Well Name: LLAMA MALL 26-35 FEDERAL	Well Location: T22S / R32E / SEC 23 / SWSE / 32.3726853 / -103.6411988	County or Parish/State: LEA / NM
Well Number: 313H	Type of Well: OIL WELL	Allottee or Tribe Name:
Lease Number: NMNM002379	Unit or CA Name:	Unit or CA Number:
US Well Number: 3002550301	Well Status: Drilling Well	Operator: OXY USA INCORPORATED

Notice of Intent

Sundry ID: 2717426

Type of Submission: Notice of Intent	Type of Action: APD Change
Date Sundry Submitted: 02/23/2023	Time Sundry Submitted: 10:48
Date proposed operation will begin: 05/01/2023

WELL LOCATION AND ACREAGE DEDICATION PLAT

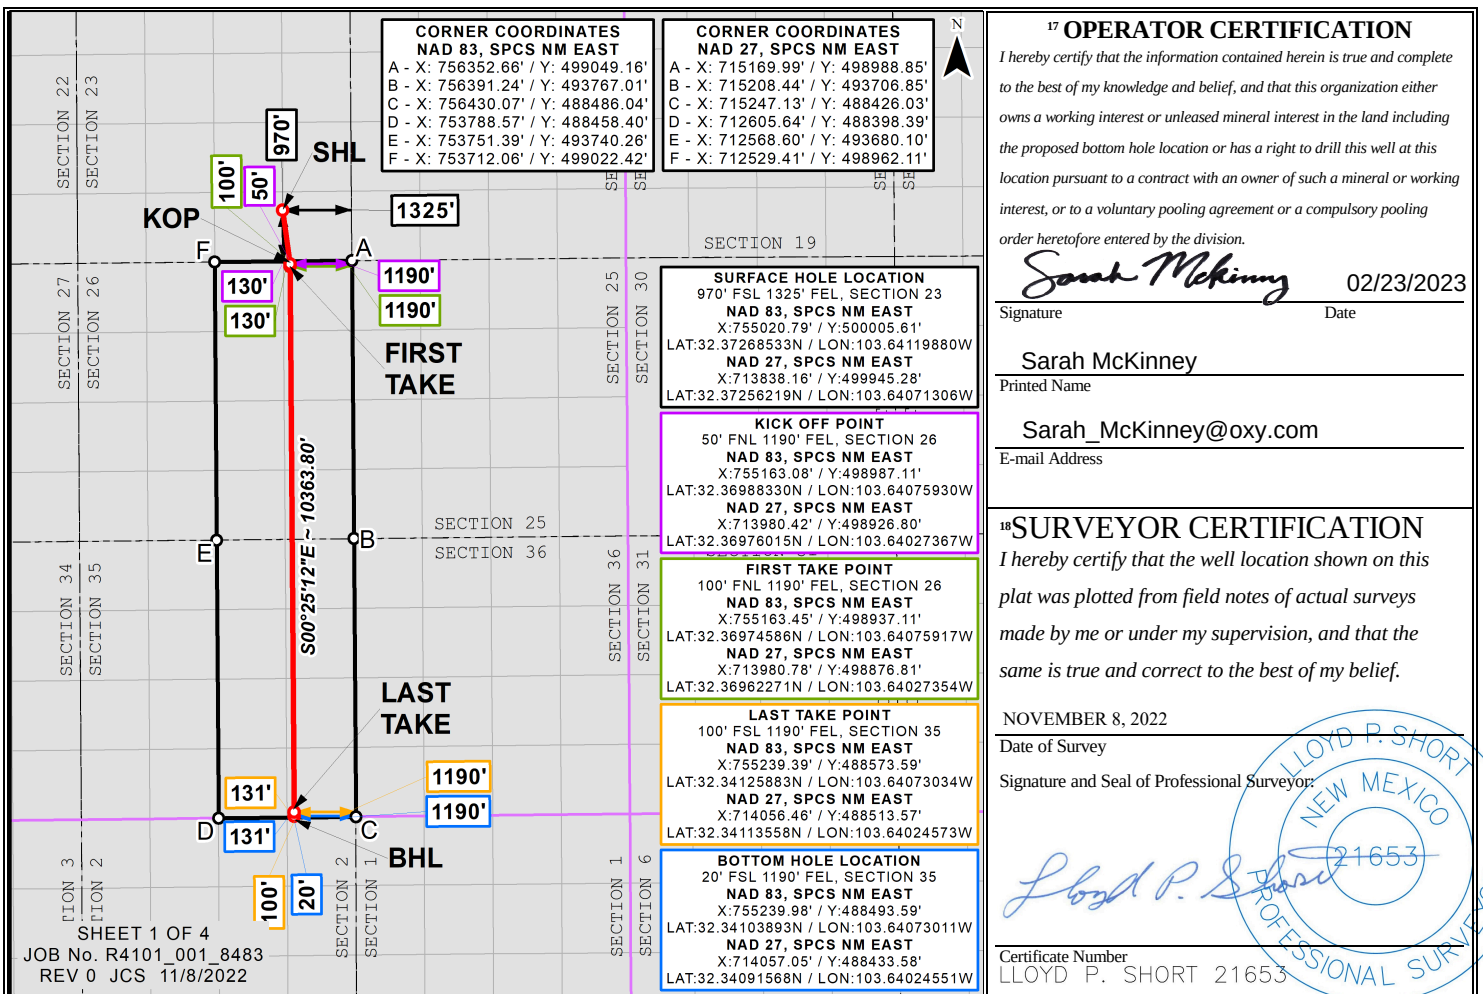
Procedure Description: OXY USA INC. respectfully requests approval to amend the subject well AAPD, the BHL is changing from 20' FSL & 1000' FEL to 20' FSL & 1190' FEL. The pool is changing from Red Tank; Bone Spring to WC-025 G-08 S223227D; Upper Wolfcamp. The updated C102 is attached, along with the updated drill plans, and supporting drilling documents.

UL or lot no.	Section	Township	Range	Lot Idn	Feet from the	North/South line	Feet from the	East/West line	County
P	35	22S	32E		20	SOUTH	1190	EAST	LEA
